Report No.: SIR-05-044-A
Revision No.: 0
Project No.: GE-10Q
File No.: GE-10Q-401
April 2007

**Pressure-Temperature Limits Report
Methodology for Boiling Water Reactors**

SUBJECT: FINAL SAFETY EVALUATION FOR THE BOILING WATER REACTOR
OWNERS' GROUP (BWROG) STRUCTURAL INTEGRITY ASSOCIATES
TOPICAL REPORT (TR) SIR-05-044, "PRESSURE TEMPERATURE REPORT
METHODOLOGY FOR BOILING WATER REACTORS" (TAC NO. MC9694)

Figure 2-7: Nozzle Thickness Definition

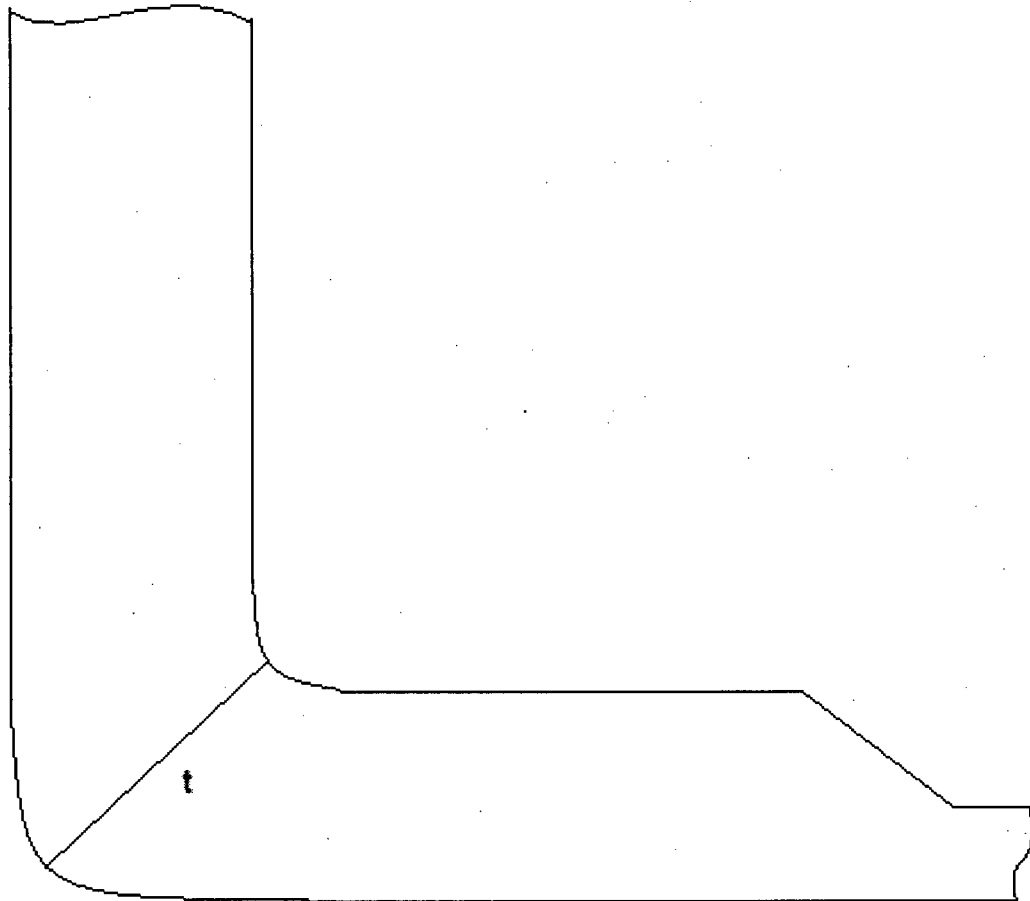
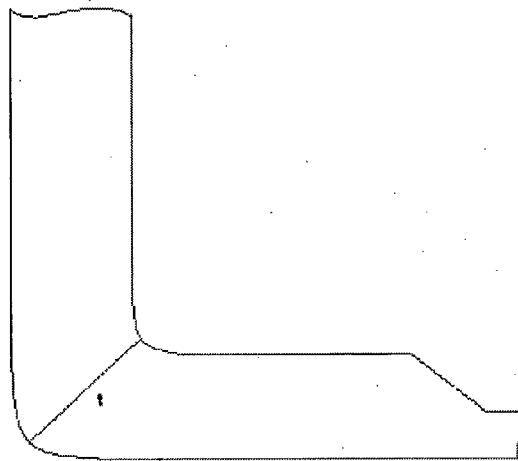
The non-beltline region analysis method that was contained in Section 2.5 has been deleted and replaced with a methodology that is described in the BWROG response to RAI No. 3. In this methodology the location to be analyzed for determining the highest stresses in the non-beltline region is the feedwater nozzle. The reference temperature, RT_{NDT} , used in the analysis is the limiting value for all non-beltline nozzles. The stress intensity factors for the feedwater nozzle may be calculated from a detailed finite element model analysis of the nozzle. The stress distribution from the finite element analysis is fit with a third order polynomial. The stress intensity factors for the nozzle corner use the coefficients from the stress distribution polynomial and a method proposed in General Electric (GE) Topical Report NEDE-21821-02 (Reference 14) for calculating stress intensity factors for nozzle corner cracks. The stress intensity factor solutions documented in Reference 14 were verified by independent analysis and experiment. Reference 14 was approved by the NRC staff in a letter from D. G. Eisenhower (NRC) to R. Gridley (GE) dated January 14, 1980 (ADAMS Legacy Library Accession No. 8002070141). The NRC staff concluded that each step in the GE analysis is acceptable, but had specific comments. Since none of the comments were directed at the stress intensity solutions for the nozzle corner crack, the stress intensity solutions proposed were considered acceptable for evaluating nozzle corner cracks. The proposed methodology uses the stress intensity factors from both thermal and pressure stress to develop P/T limits based on the structural factors described in Appendix G to Section XI of the ASME Code. The NRC staff finds the non-beltline methodology acceptable since it meets the requirements of ASME Code, Section XI, Appendix G and the stress intensity factors are determined using a previously approved methodology. However, the NRC staff requires that the information provided in response to RAI No. 3 be incorporated into the -A version of the LTR.

Section 2.5 of the LTR and the methodology proposed in response to RAI No. 3 to describe methodologies for calculating bending and membrane stresses using computer code finite element analyses. If these finite element analyses are to be utilized by licensees to develop P/T limits, the NRC staff requested, in RAI No. 2, that the BWROG provide the following:

For a path through the limiting nozzle inner blend radius corner, as shown in Figure 2-7, the thermal and pressure hoop stress distributions should be extracted from the finite element model. Each of the stress distributions should be fit with a third-order polynomial that reasonably fits the calculated stresses in the region of interest.

t = thickness of the cross-section through the limiting nozzle inner blend radius corner, as shown in Figure 2-7.
 $C_{0t}, C_{1t}, C_{2t}, C_{3t}$ = thermal stress polynomial coefficients based on fits to finite element analysis.

The figures below will be added as new Figures 2-7 and 2-8 of the TR.
